AAR Docket T94.1.1 - 1995

RE: Comments On Letter 5/13/97 - Proposed Drawings for M - 1002

MESSAGE: M-1002 Proposed Figures (AAR Docket T94.1.1 - 1995)

FIGURE E8.5
MANWAY COVER FOR 20" MANWAY
VINYL CHLORIDE TANK CARS

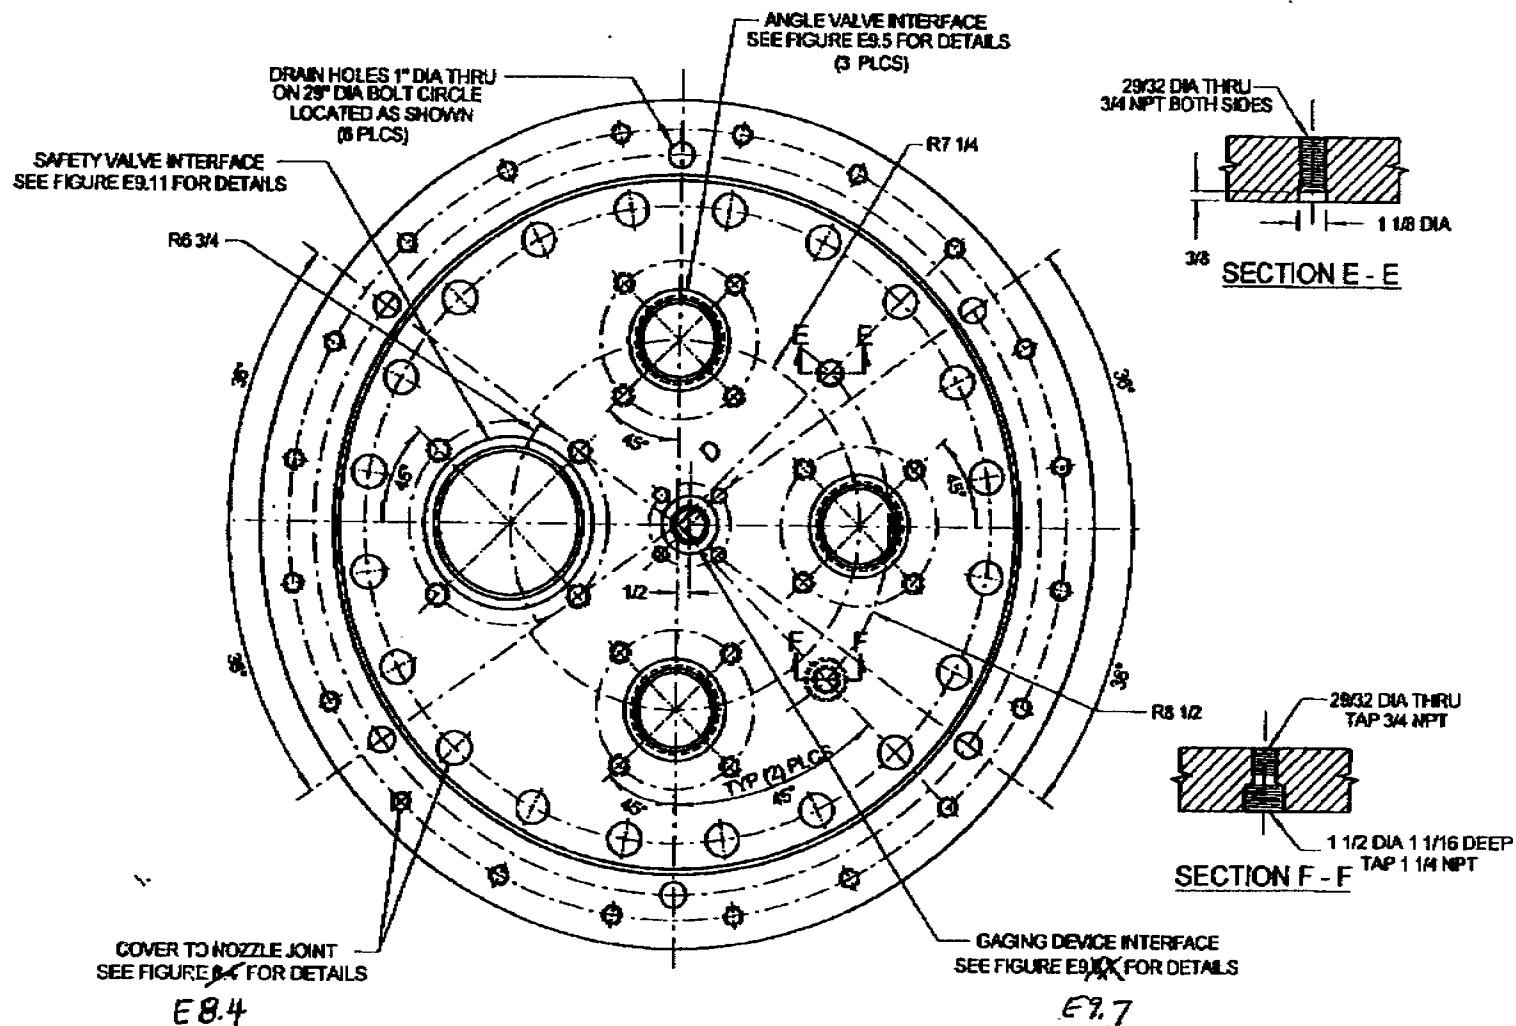
New Figure 8.5 - Identify Section EE and FF as Sample Opening and Thermowell Opening, and also, show them as OPTIONAL. Rotate drawing so tank longitudinal centerline is horizontal across the page like other coverplates figures.

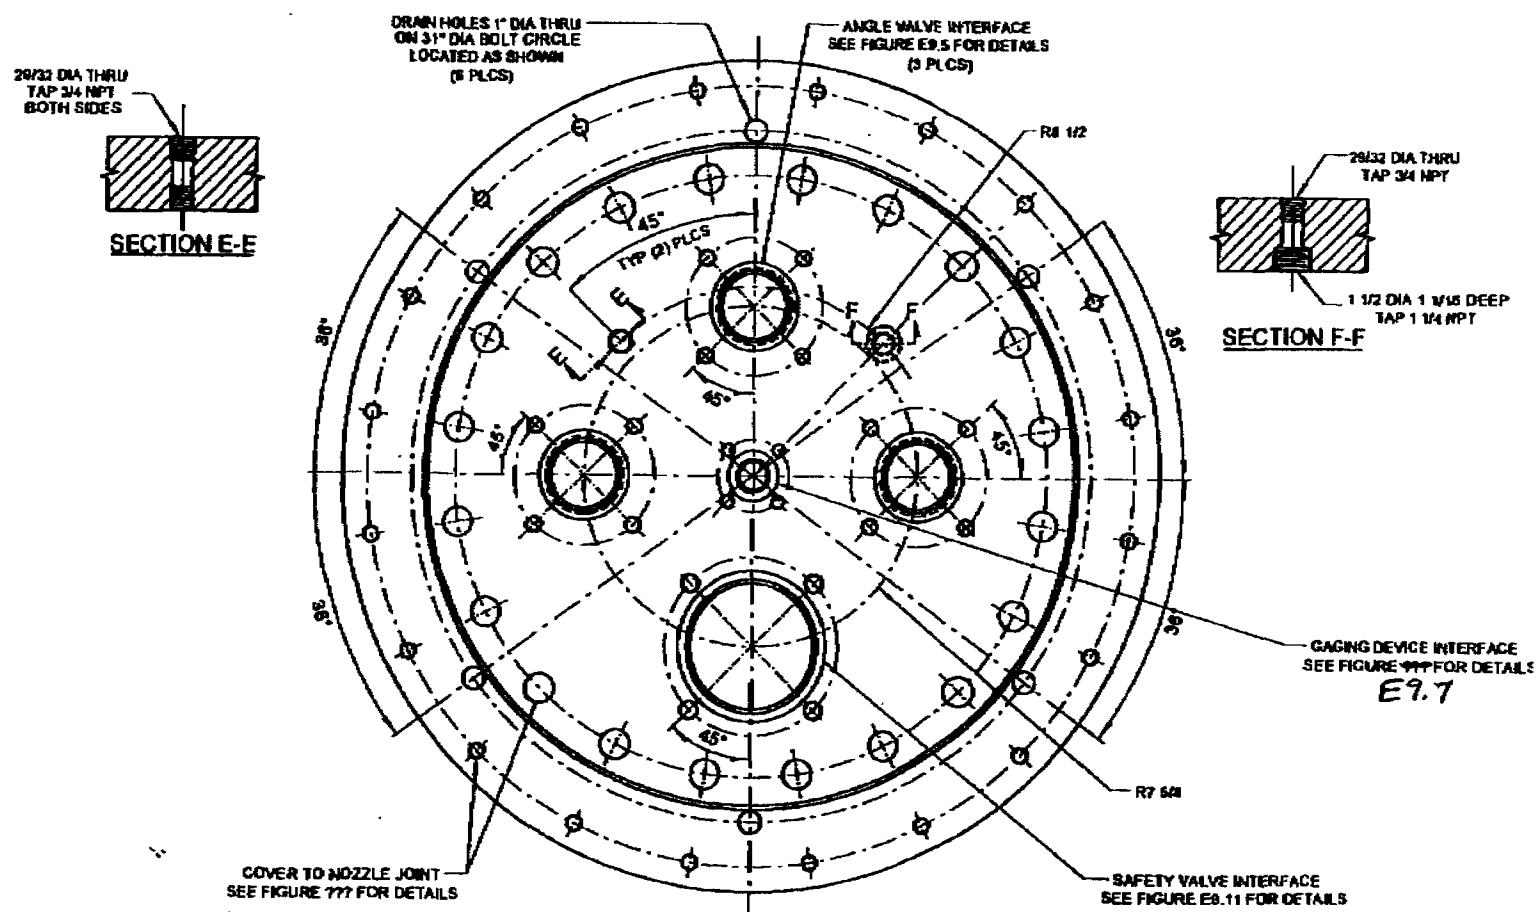
New Figure 8.6 - Same stuff with thermowell and sample line. Must show as OPTIONAL. Longitudinal centerline is OK as shown.

FIGURE ????
DETAIL FOR COVER TO NOZZLE JOINT
FOR 22" MANWAY VINYL CHLORIDE TANK CARS

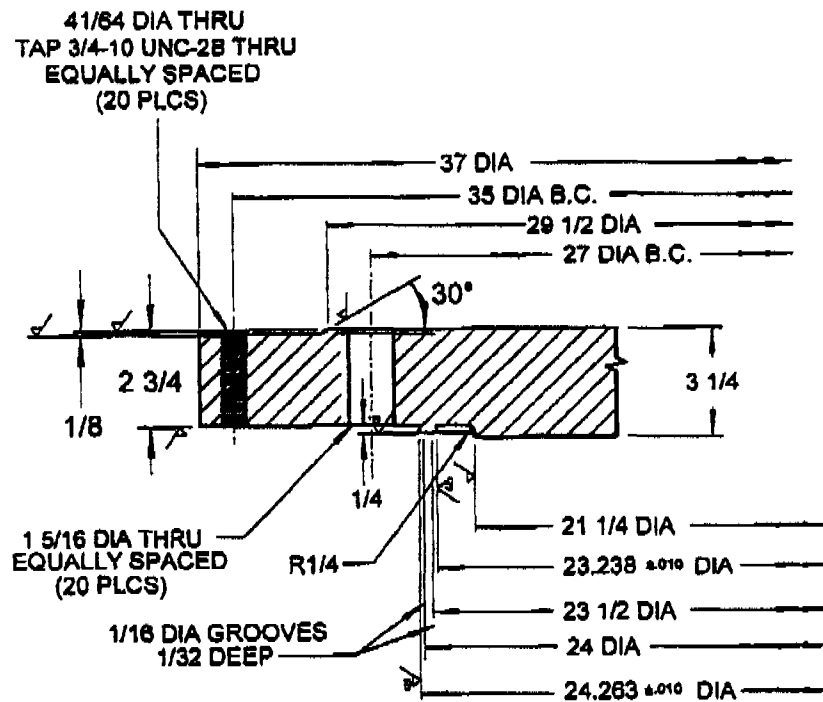
New Figure 8.7 - Correct the coverplate thickness to 1 3/4" on the OD edge of the coverplate (2 3/4 is in error) and to 2 3/4" on full plate thickness (3 1/4 is in error). Add a section of a 22" nozzle and nozzle flange to this drawing for reference.

This lacks the nozzle joint portion similar to Figure E8.4. Need to get a tank builder's drawing on this to complete.

FIGURE ?? (6)
PROTECTIVE HOUSING FOR 20" AND
22" MANWAY VINYL CHLORIDE TANK CARS

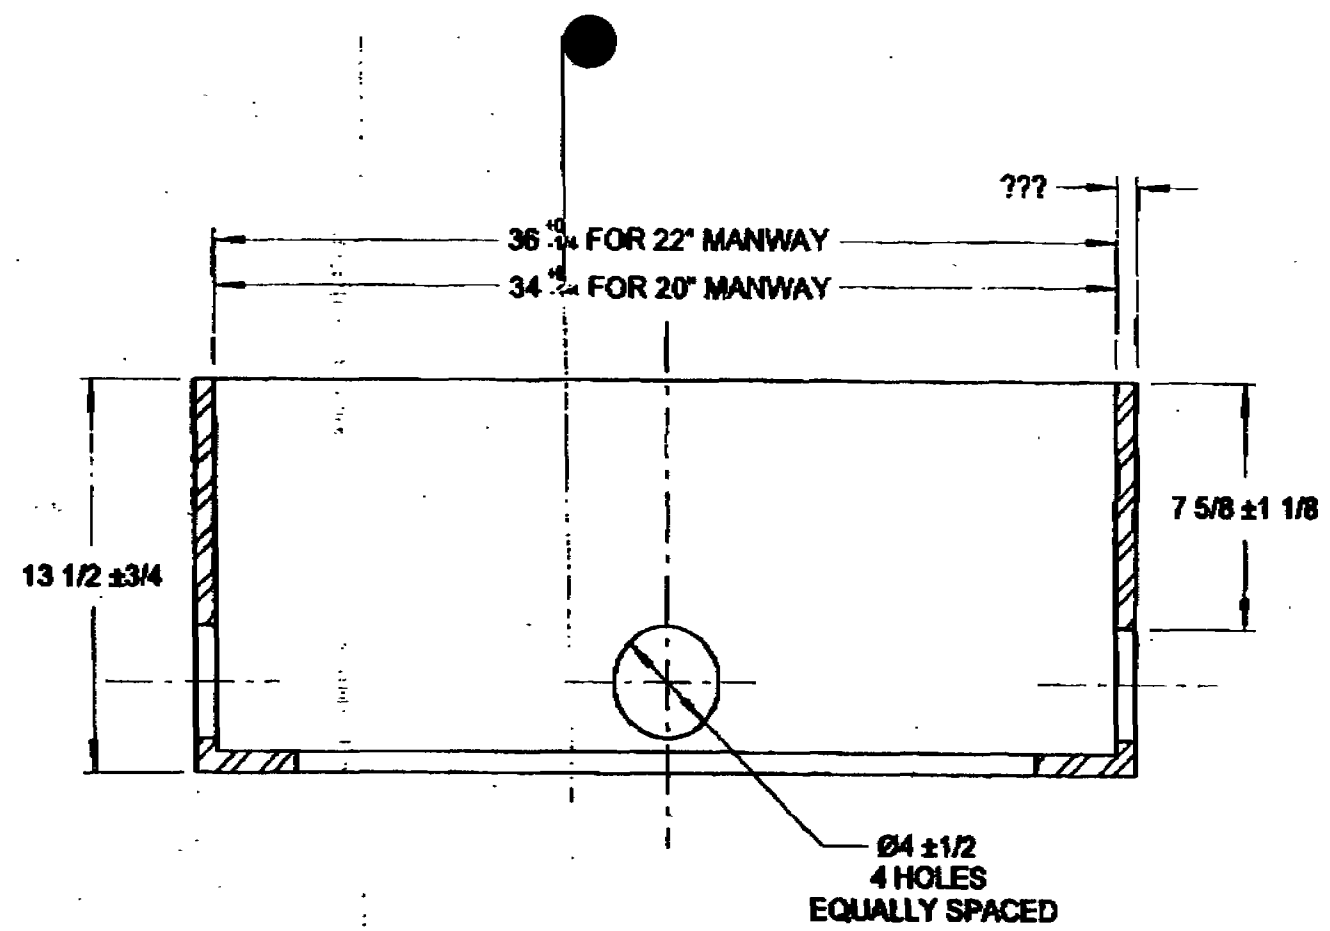
New Figure 8.8 - I cannot comment on the Protective Housing dimensions. I have no knowledge of them.

This is based on Figure 6 from CGA Pamphlet P-10. I believe this is needed so that the emergency kit will work. This should be confirmed.
